Meeting: 8/21/2024
Project: Southeastern Glass Building
Applicant: John Allen

Proposed replacement of five windows on the fifth story of the Southeastern Glass Building.

8-B-24-DT

APPLICATION FOR CERTIFICATE OF APPROPRIATENESS

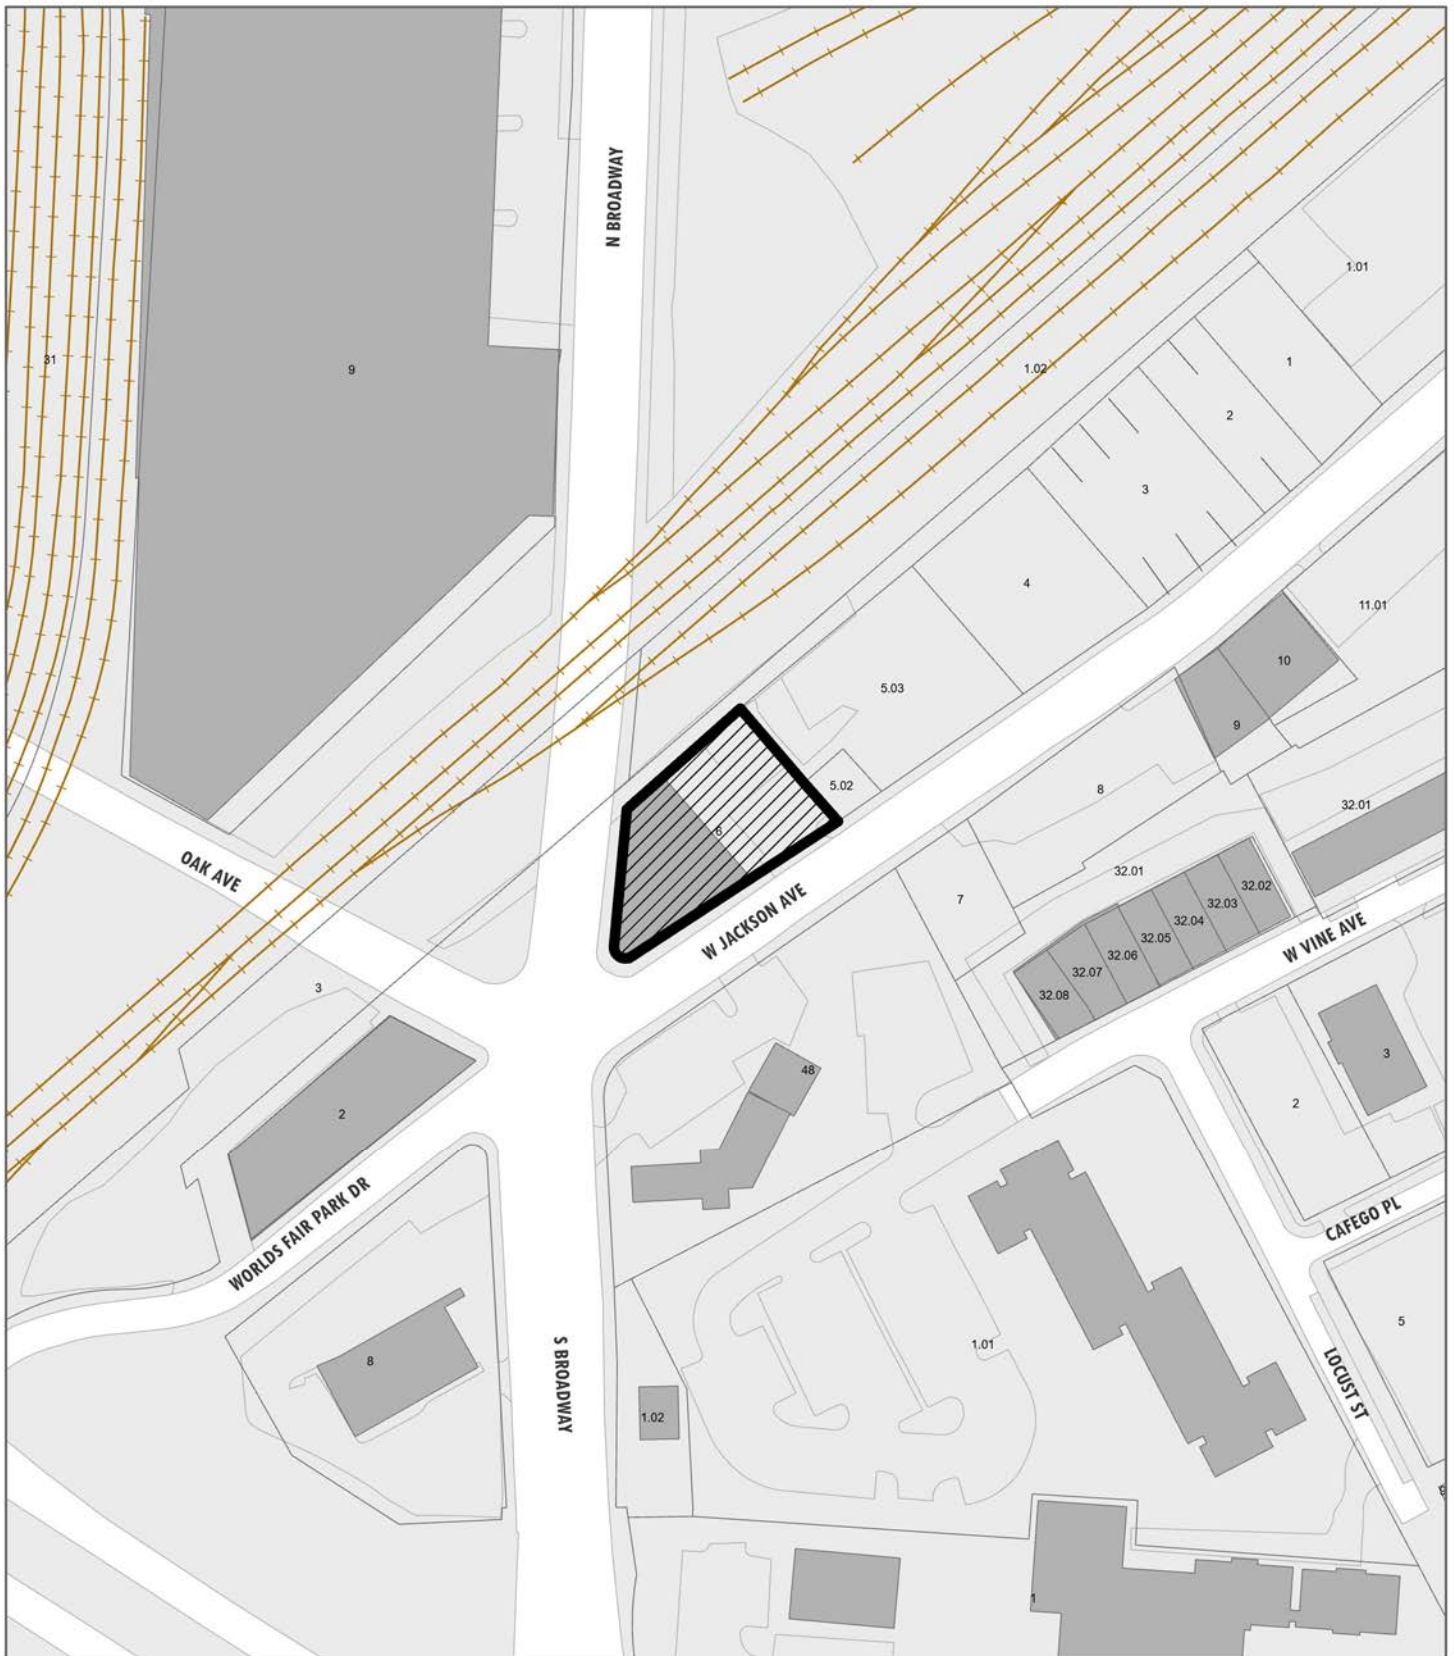
Full replacement windows were approved by the DRB in March 2024 (2-B-24-DT), with final specifications submitted to staff in July 2024 (included in packet, Advanced Glass Cooperative, Inc. specification). The intent was to issue a blanket approval of one specific type of window, approving a specification which all replaced windows shall be match moving forward. The proposed windows differ from the previous approval primarily in operation and design, featuring a six-light casement window instead of an awning window. The current application notes the slightly larger size of the fifth story windows.

Guidelines recommend that if repairs are not possible, replace with matching windows, including duplicating design,

operation, material, glass size, muntin arrangements, profiles, and trim. The proposed replacement windows will vary in design; material (using a surface-applied grid, of aluminum instead of the original steel); and profiles (surface-applied exterior muntins are typically more thin than steel muntins).

For the previous application, the contractor submitted a detail of the existing steel muntins, which are flat and measure approximately $\frac{3}{4}$ -inch, and a profile of the proposed, which are flat and measure $\frac{3}{4}$ -inch. The proposed windows for the fifth floor reflect these measurements, other than the section surrounding the casement window. Overall, the variation in operation is not significantly different from the existing windows or the proposed specification featuring the awning windows. From the street level, the windows will be visually similar. The applicant is in conversation with the HOA regarding using the casement product instead of the awning window approved in March 2024.

Staff recommends approval of Certificate 8-B-24-DT as submitted.
